**ADDENDUM  
NO. 3**

**October 11, 2024**

**Whiteland High School Ph 2: Café Kitchen Band Choir Auditorium**  
**300 E. Main Street**  
**Whiteland, IN 46184**

2 AUDITORIUM POWER SEQUENCING SYSTEM DIAGRAM N.T.S.

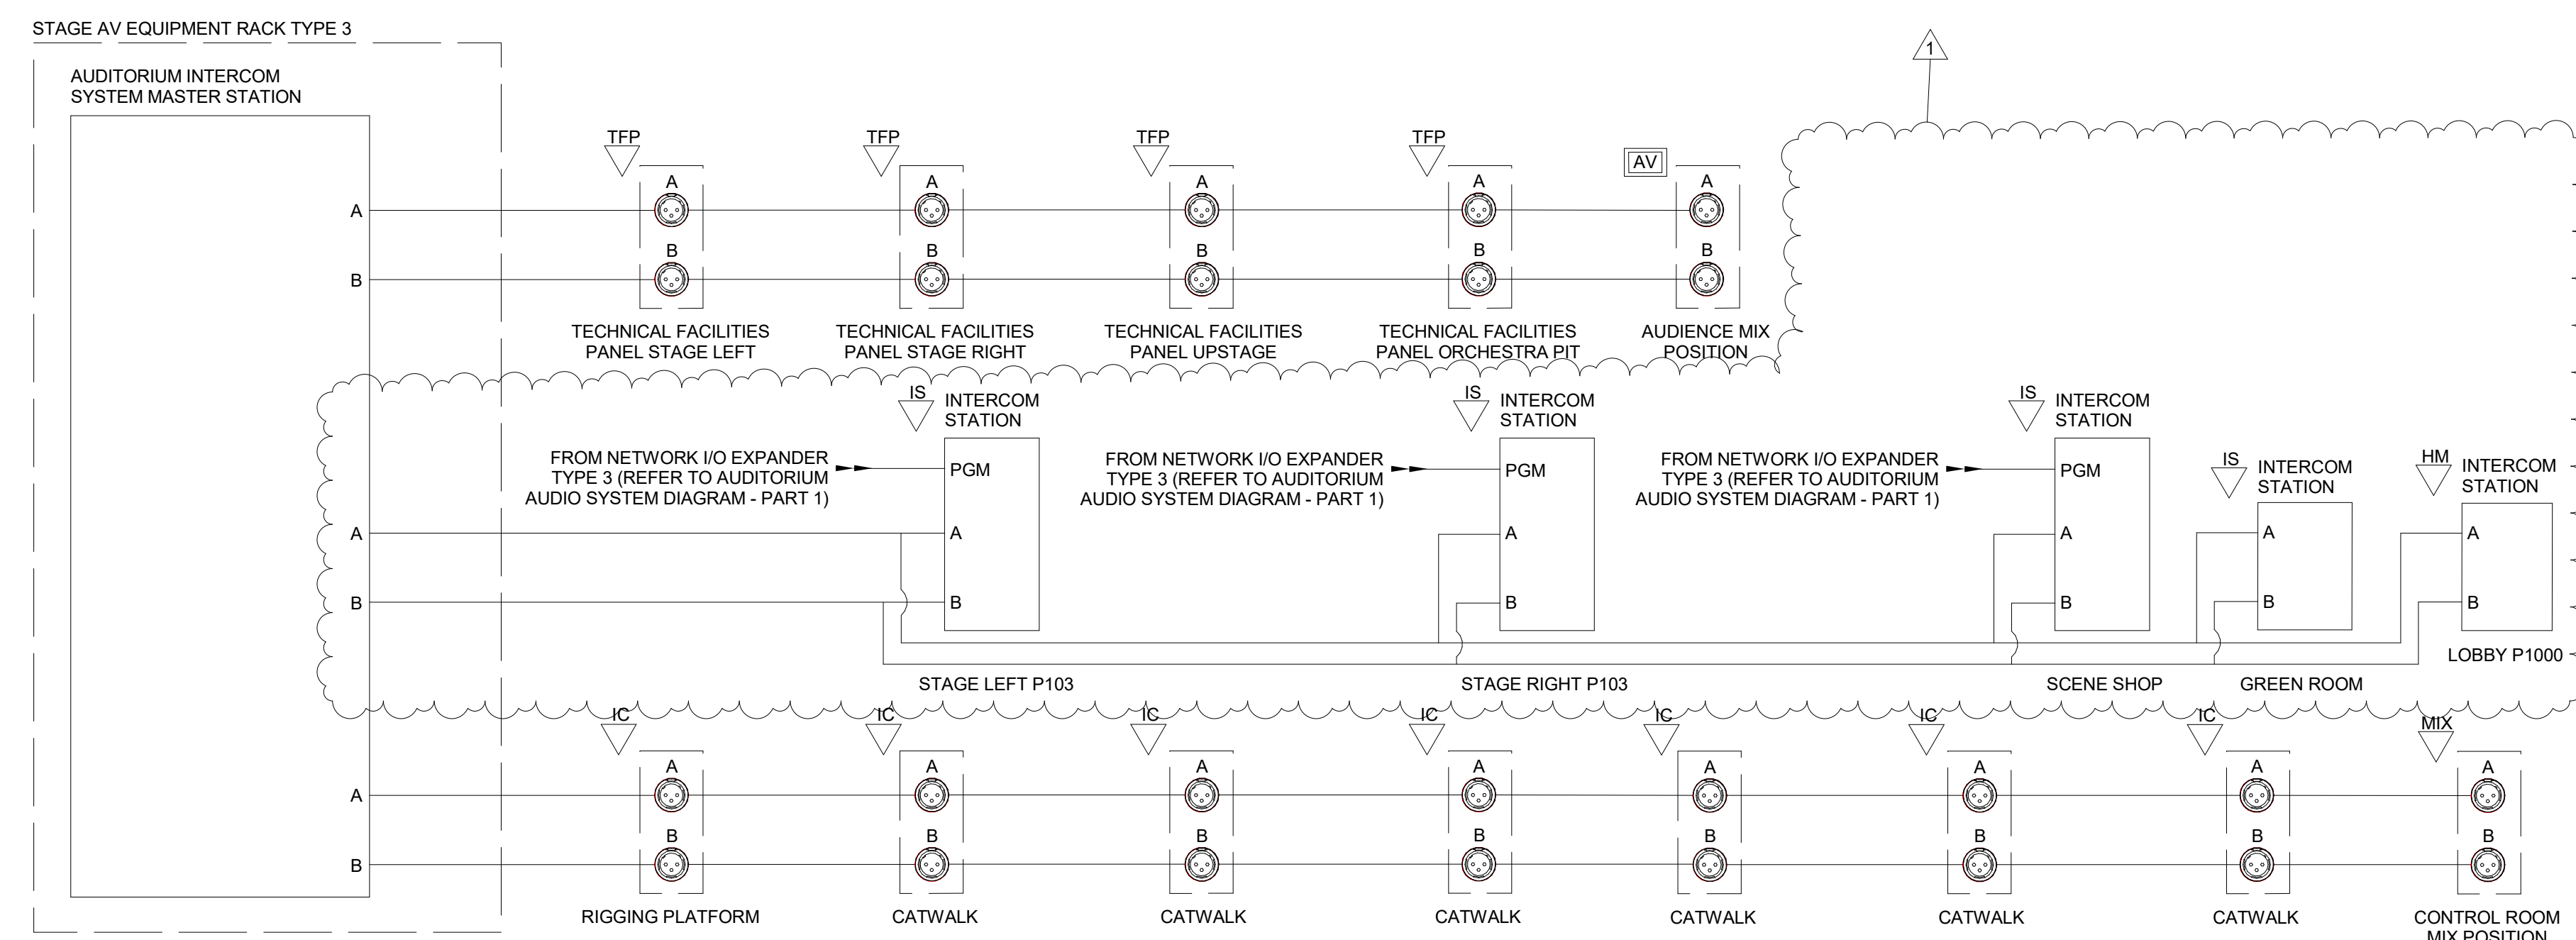
- a. Updated the Auditorium Power Sequencing AV Diagram. Added clearer connectivity from the power sequencer and UPSs in each AV equipment rack. Added clearer instructions on where to plug in each piece of equipment.
- b. Removed LAN connections from all wireless microphone receiver type 2 in the Auditorium Audio System AV Diagram – Part 2
- c. Added two wireless microphone chargers to the Auditorium Audio System AV Diagram – Part 2
- d. Added two additional intercom stations located on the stage right and stage left side of Stage P103. Put all intercom stations on dedicated set of A and B channel outputs.

AUDITORIUM LOUDSPEAKER AV  
 DIAGRAM - PART 1  
 1 N.T.S.

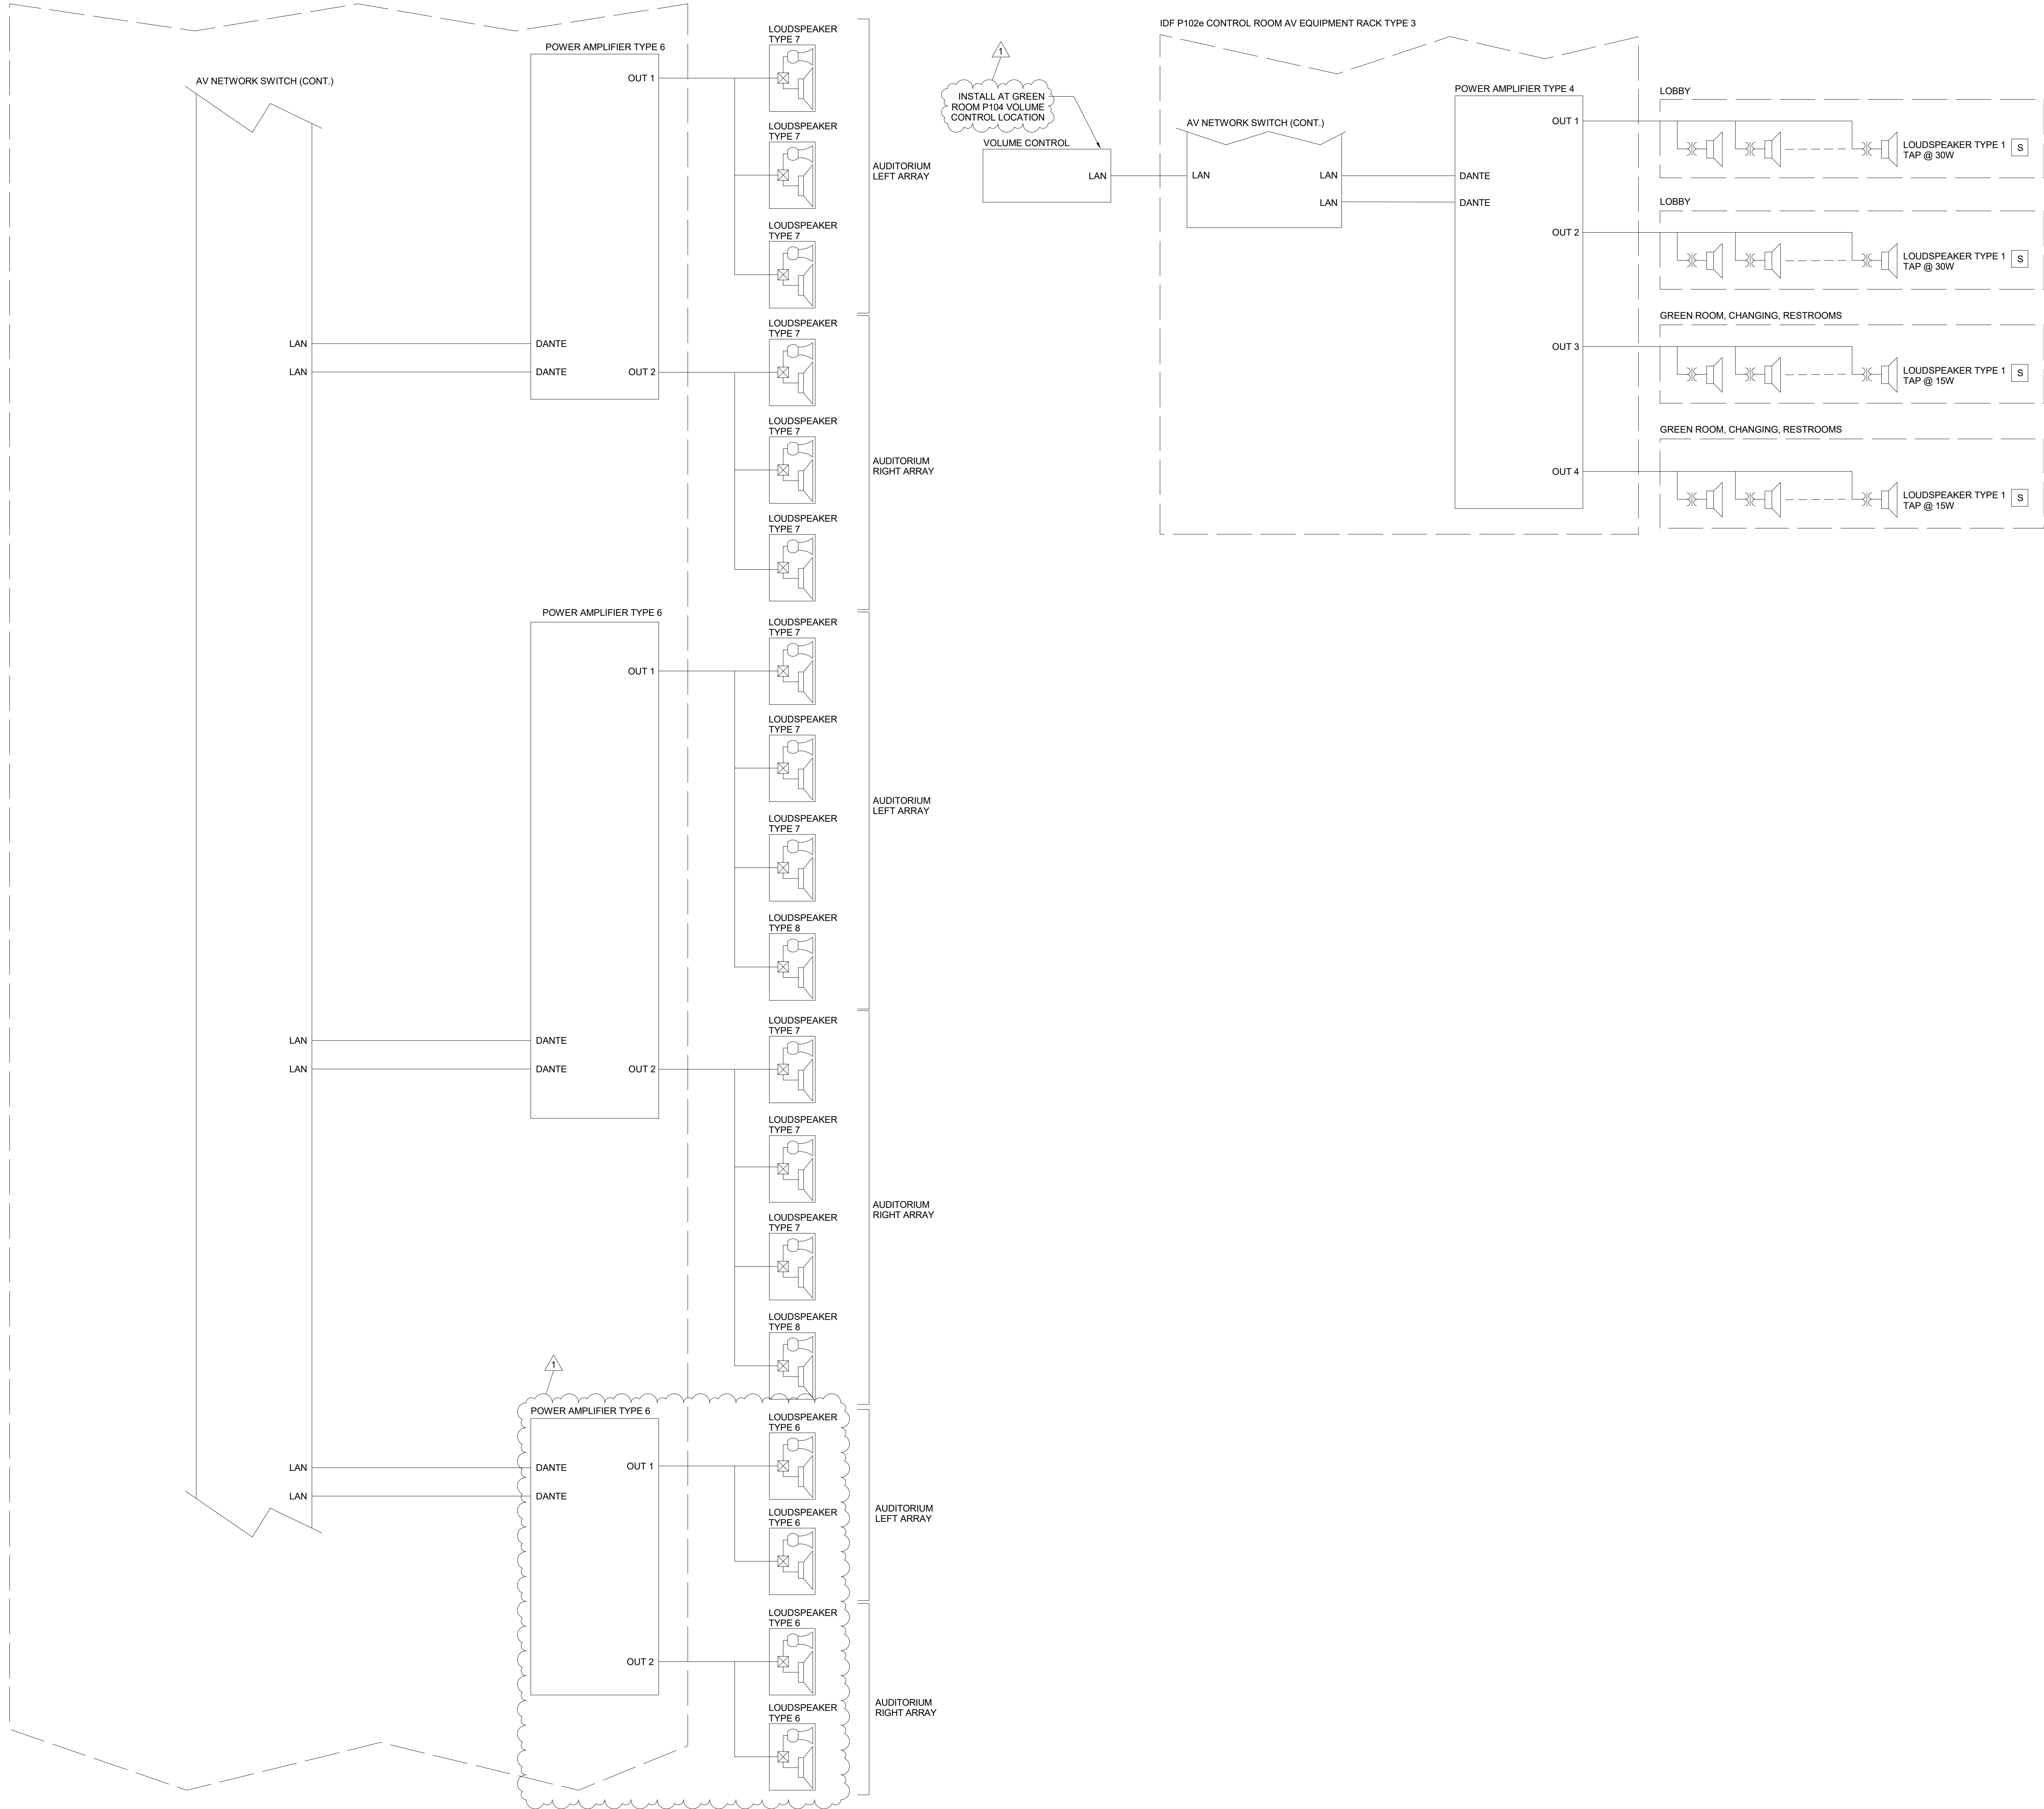
- a. Changed the power amplifier type feeding subwoofer array loudspeakers type 6 to power amplifier type 6 in the Auditorium Loudspeaker AV Diagram – Part 1
- b. Added additional callout and instructions to the volume control connected to the AV network switch located in the stage AV equipment rack to the Auditorium Loudspeaker AV Diagram – Part 1

1 AUDITORIUM LOUDSPEAKER AV DIAGRAM - PART 2  
N.T.S.

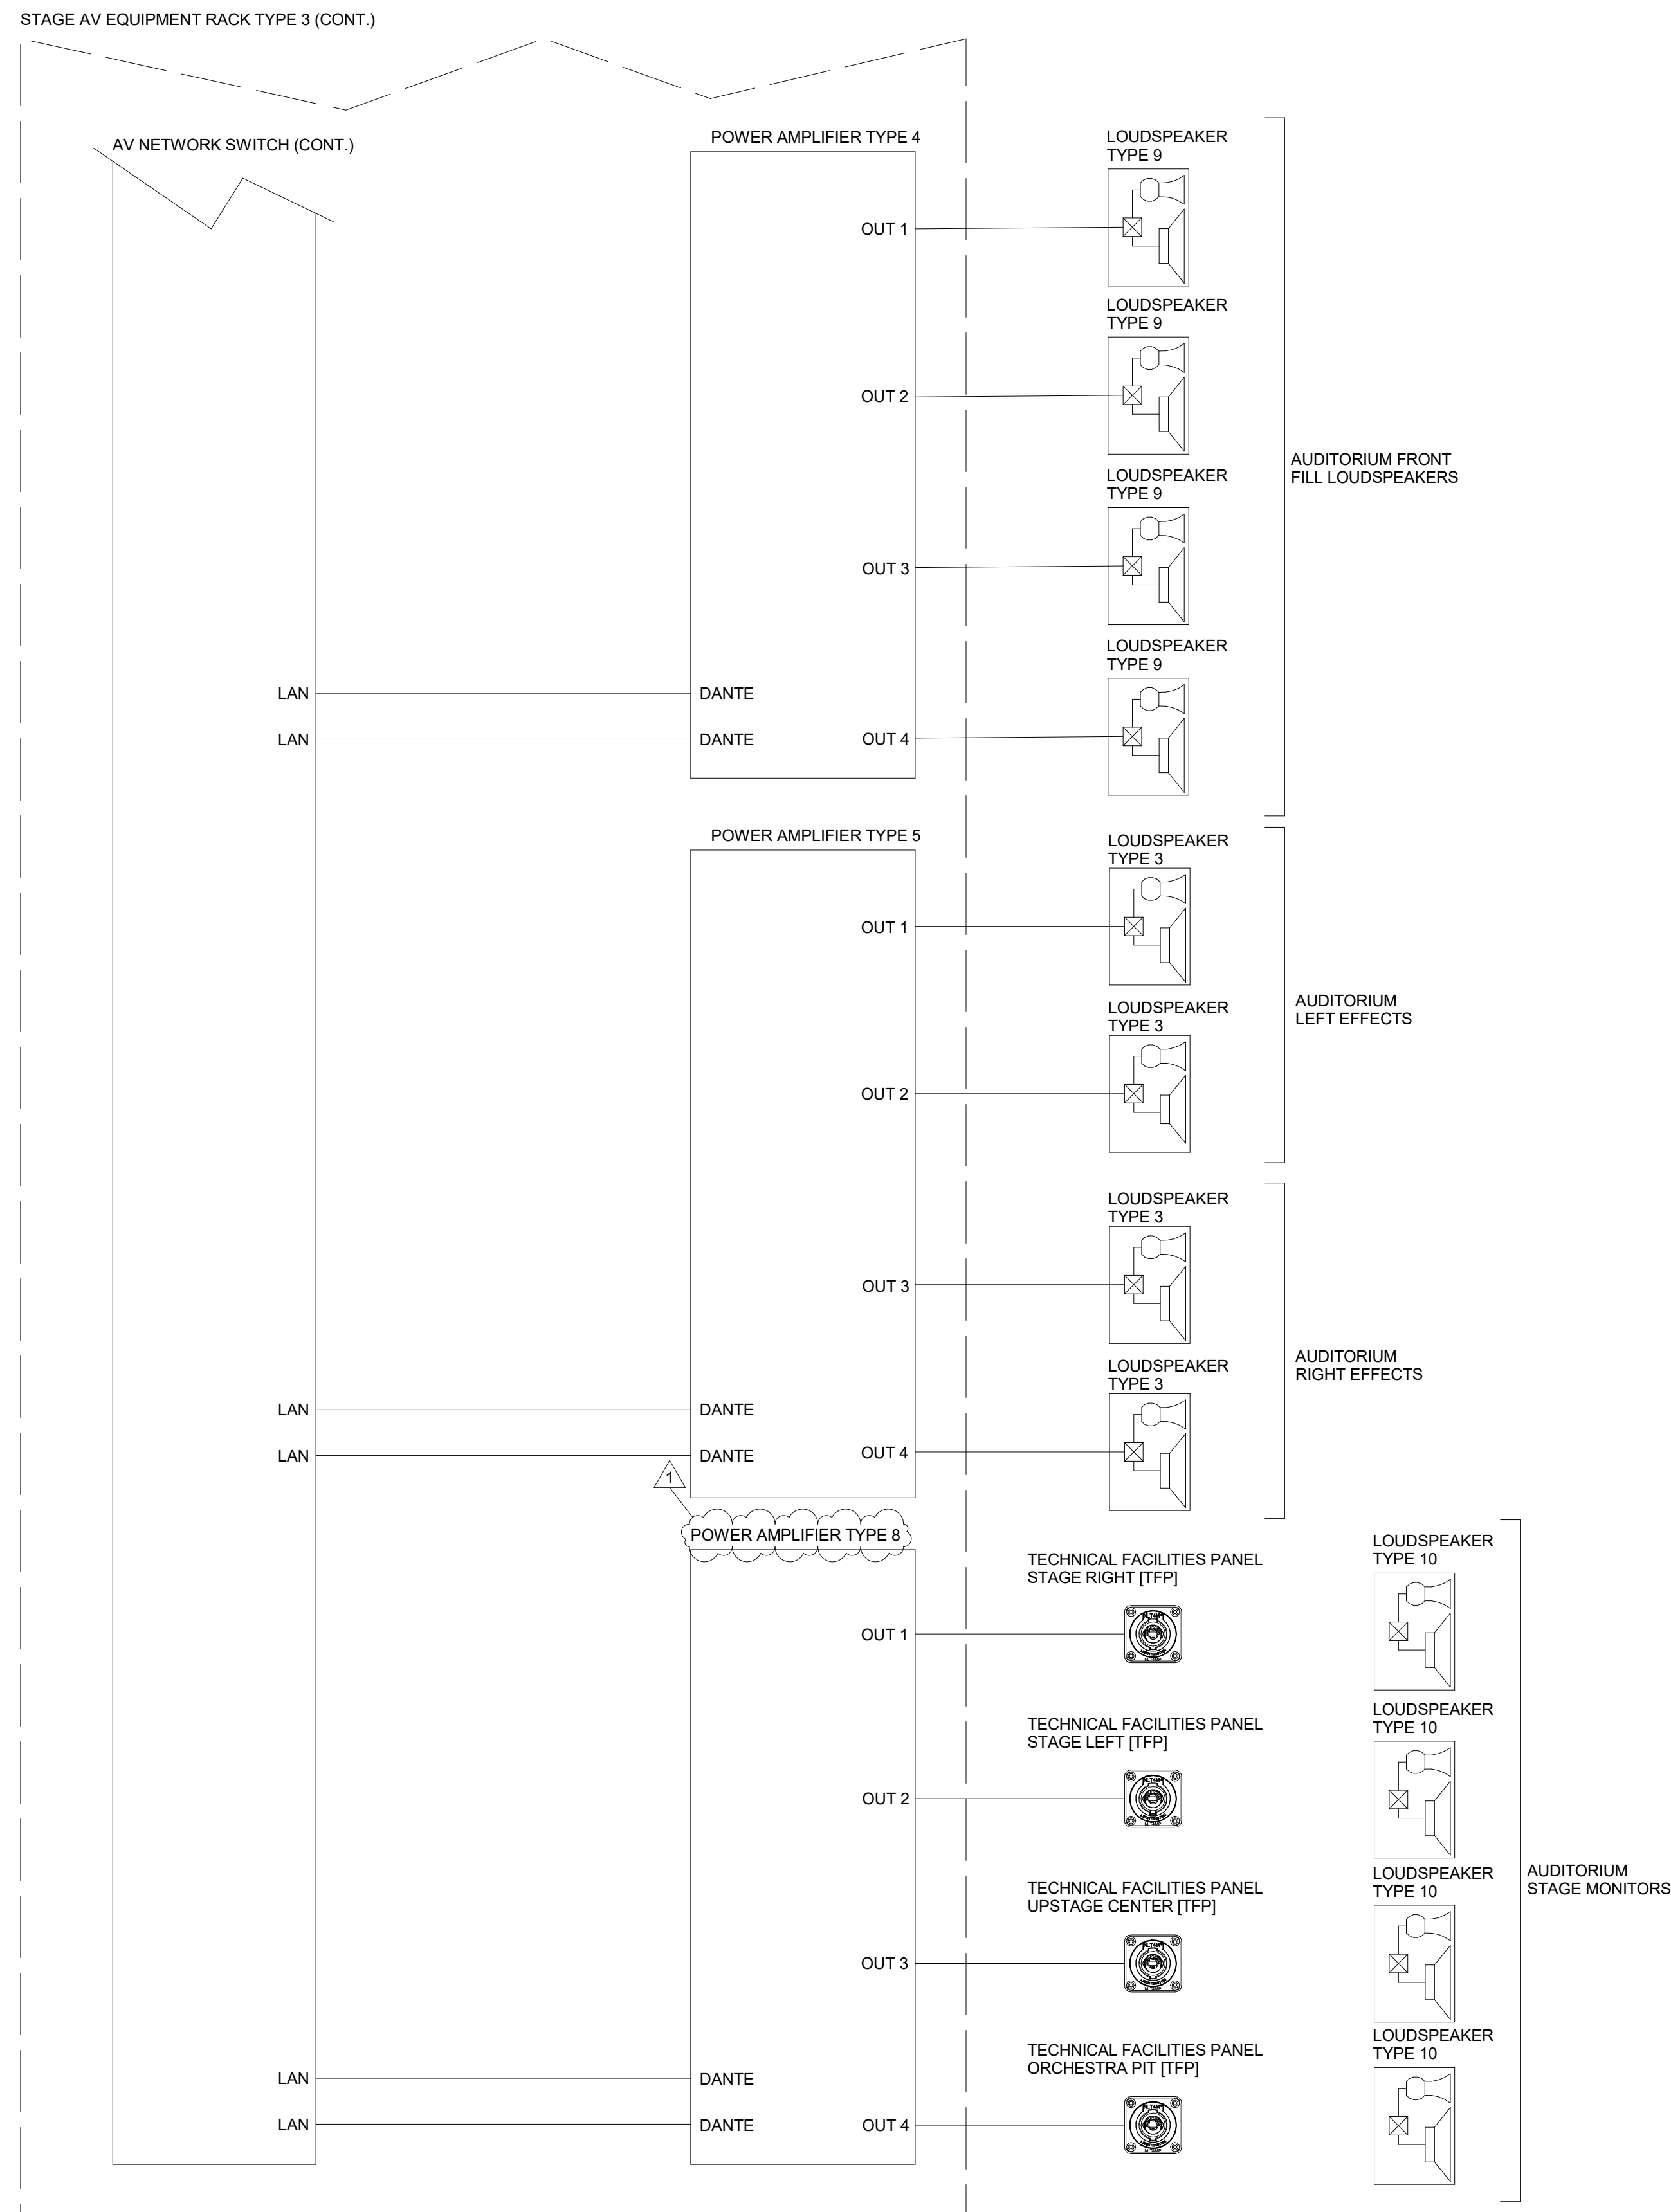
- a. Changed the power amplifier type feeding stage monitor loudspeakers type 10 to new power amplifier type 8 in the Auditorium Loudspeaker AV Diagram – Part 2
- b. AV diagrams formerly placed on Sheet 313 are now placed on Sheet 314
